## ATTACHMENT 'A': STAFF ASSESSMENT OF PROPOSED TRANSPORTATION OPTIONS

### Option #1: Bearspaw Village Road

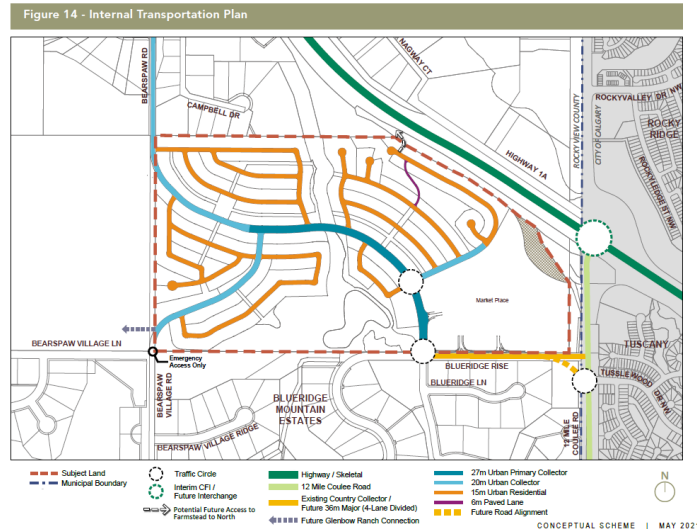
This amendment would require that access from the plan area to Bearspaw Village Road to the south be emergency access only. Possible future connections to Glenbow Ranch Area J would be considered at future subdivision stages.

- Conversion of the Bearspaw Village Road access to a gated emergency access.
- The main access points to the development would be from 12 Mile Coulee Road to the east and Bearspaw Road to the north.
- The proposal complies with the access requirements of NFPA 1141 (fire code) which requires three points of access for a development of this scale of which one can be an emergency access.
- Aligns with the transportation map from the Glenbow Ranch ASP as it provides secondary access to the plan area.
- Creates a secondary emergency access for the south Bearspaw area.

- 1) Add annotation to Figures 13 & 14 that identifies the connection to Bearspaw Village Road for emergency access only.
- 2) Amend policy 7.2.3 as follows:

Roads, pathways, and trails shall connect to adjacent neighbourhoods and open space and accommodate a range of users where suitable opportunities exist and in consultation with adjacent residents and landowners. **Bearspaw Village Road shall only be considered for emergency access and this shall be detailed at the subdivision stage in consultation with adjacent residents and landowners.**
- 3) Amend the second paragraph of section 7.1 as follows:

**An second-emergency** access to the southwest to Bearspaw Village Road **will would also** provide residents of south Bearspaw **with an alternative route through the development area to the Bearspaw School and Highway 1A. This route will also provide with** a secondary emergency access route **for residents of south Bearspaw.**

## Option #2 Bears paw Road

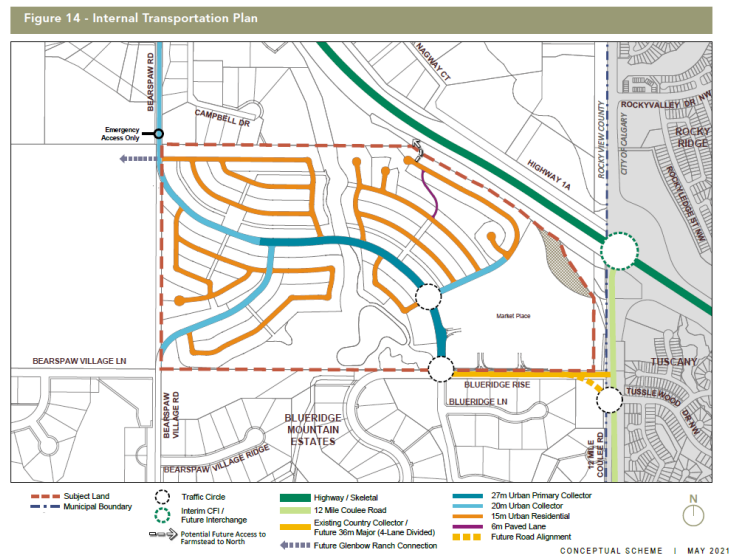
This amendment would require that access from the plan area to Bears paw Road to the north be emergency access only. Possible future connections to Glenbow Ranch Area J would be considered at future subdivision stages.

- Administration does not recommend Council proceed with this option.
- This would eliminate a permanent access to Bears paw Road.
- In essence, all traffic accessing this development would be required to use 12 Mile Coulee Road at Blueridge Rise and via TWP RD 252 to Bears paw Village Road.
- Albeit there are separate access points, the primary access is solely from 12 Mile Coulee Road.
- The proposal complies with the access requirements of NFPA 1141 (fire code) which requires three points of access for a development of this scale.

- 1) Add annotation to Figures 13 & 14 that identifies the connection to Bears paw Road for emergency access only.
- 2) Amend policy 7.2.3 as follows:

**Policy 7.2.3**  
Roads, pathways, and trails shall connect to adjacent neighbourhoods and open space and accommodate a range of users where suitable opportunities exist and in consultation with adjacent residents and landowners. **Bears paw Road shall only be considered for emergency access and this shall be detailed at the subdivision stage in consultation with adjacent residents and landowners**
- 3) Amend the first sentence of section 7.1 to read as follows:

Primary access points to the site are ~~is~~ from 12 Mile Coulee Road via Blueridge Rise in the southeast and Bears paw Road in the northwest, with secondary and emergency access from the southwest and northwest (see Figure 13 - Regional Transportation Plan and Figure 14 - Internal Transportation Plan). Intersection improvements at

**Option #3 Bearspaw Village Road & Bearspaw Road**

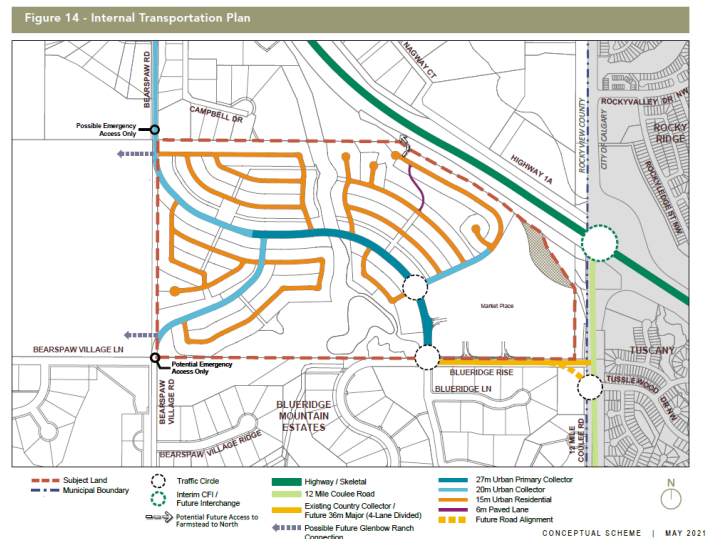
This amendment would require that access from the plan are to Bearspaw Village Road (south) and Bearspaw Road (north) be emergency access only. Possible future connections to Glenbow Ranch Area J would be considered at future subdivision stages.

- Administration does not recommend Council proceed with this option.
- Does not comply with the access requirements of NFPA 1141 (fire code) which requires three points of access for a development of this scale.
- The sole access to the development will be from 12 Mile Coulee Road at Blueridge Rise .

- Secondary access would be uncertain as the timing of development on the lands to the west are unknown.

- 1) Add annotation to Figures 13 & 14 that identifies the connection to Bearspaw Road and Bearspaw Village Road for possible emergency access only.
- 2) Amend policy 7.2.3 to read as follows:

Roads, pathways, and trails shall connect to adjacent neighbourhoods and open space and accommodate a range of users where suitable opportunities exist and in consultation with adjacent residents and landowners. **Connections to Bearspaw Village Road and Bearspaw Road shall be considered for emergency access only and this shall be detailed at the subdivision stage in consultation with adjacent residents and landowners**

Primary access points to the site are ~~is~~ from 12 Mile Coulee Road via Blueridge Rise in the southeast and Bearspaw Road in the northwest, **with secondary and/or emergency access from the southwest and northwest** (see Figure 13 - Regional Transportation Plan and Figure 14 - Internal Transportation Plan). Intersection improvements at these access points will be developer funded as required.

~~A second access to the southwest to Bearspaw Village Road will provide residents of south Bearspaw with an alternative route through the development area to the Bearspaw School and Highway 1A. This route will also provide a secondary emergency access route for residents of south Bearspaw.~~

The Grande Boulevard will have two feeder collector roads, one to the north of the marketplace and one west of the ravine, and transition to a collector towards the Northwest of the plan area ~~and its connection to Bearspaw Road.~~
